UNITED STATES PATENT AND TRADEMARK OFFICE

APPLICATION NO.	FILING DATE	FIRST NAMED INVENTOR	ATTORNEY DOCKET NO.	CONFIRMATION NO.
10/760,981	01/20/2004	George Reisch Aschauer		1980

Office Action Summary	Application No. 10/760,981	Applicant(s) ASCHAUER, GEORGE REISCH	
	Examiner Rodney H. Bonck	Art Unit 3681

DETAILED ACTION

FIG-3 REPLACEMENT SHEET

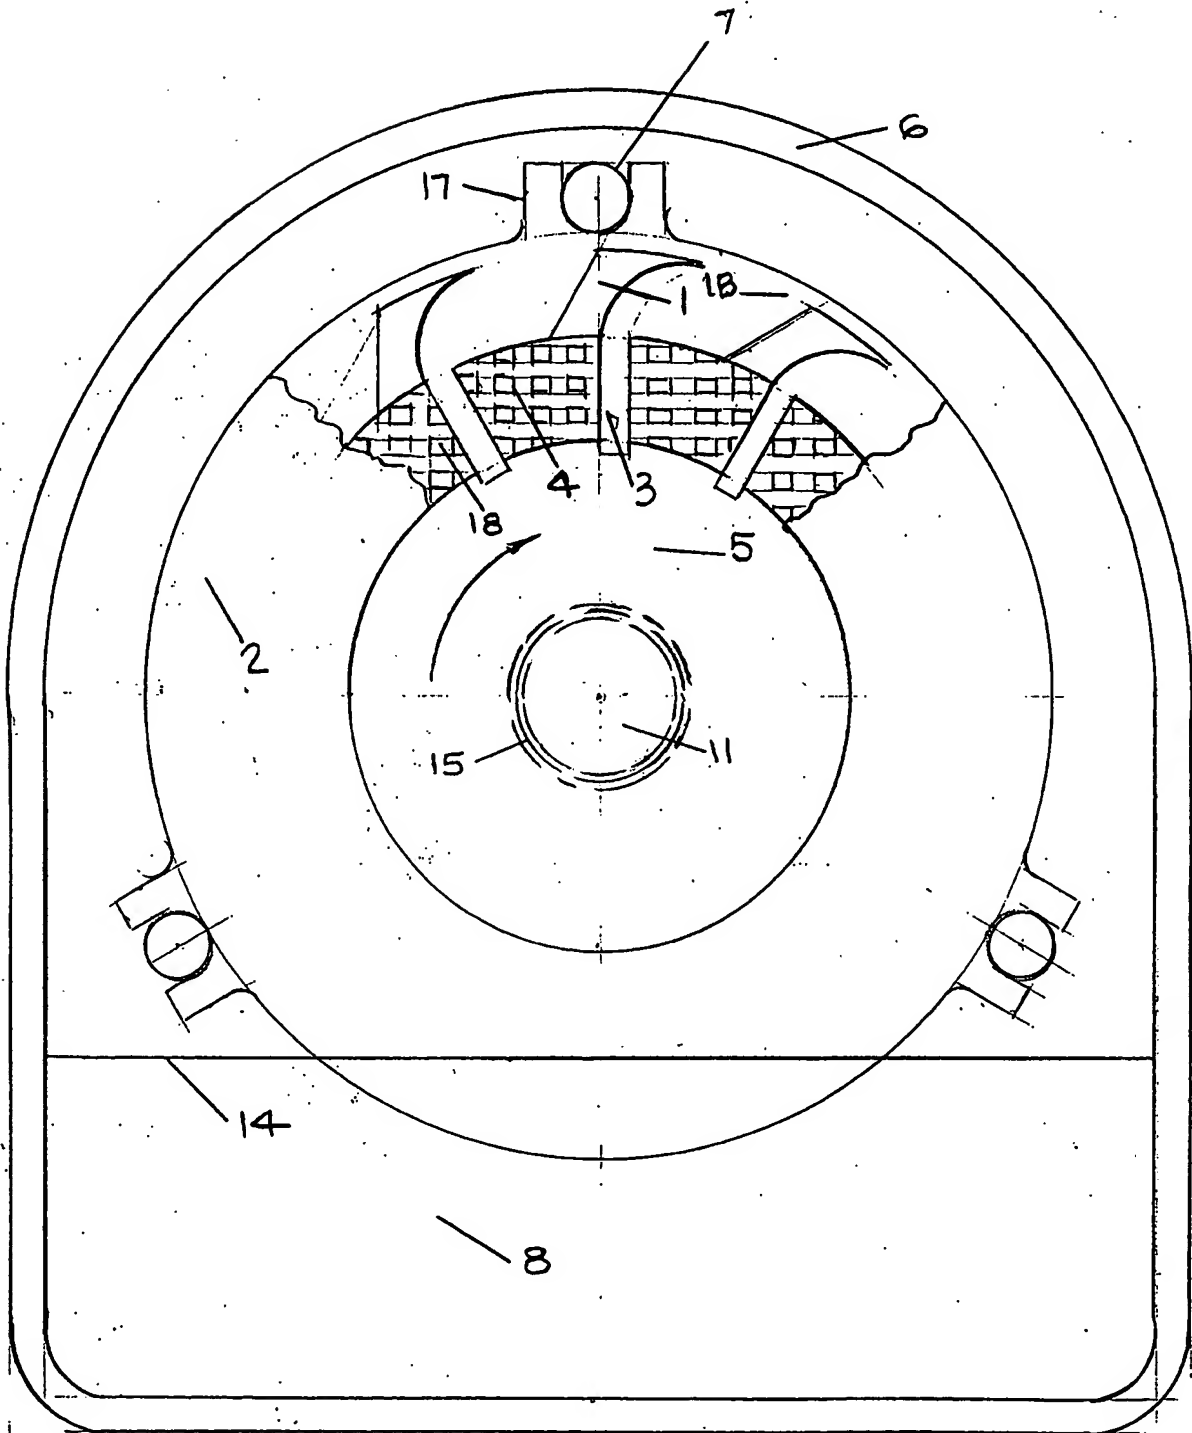
Receipt is acknowledged of the replacement sheets of drawing modifying Fig. 2 and adding Fig. 3. The examiner has approved these sheets for entry. Since modified forms are no longer shown in a single view, the previous objection to the drawings is withdrawn.
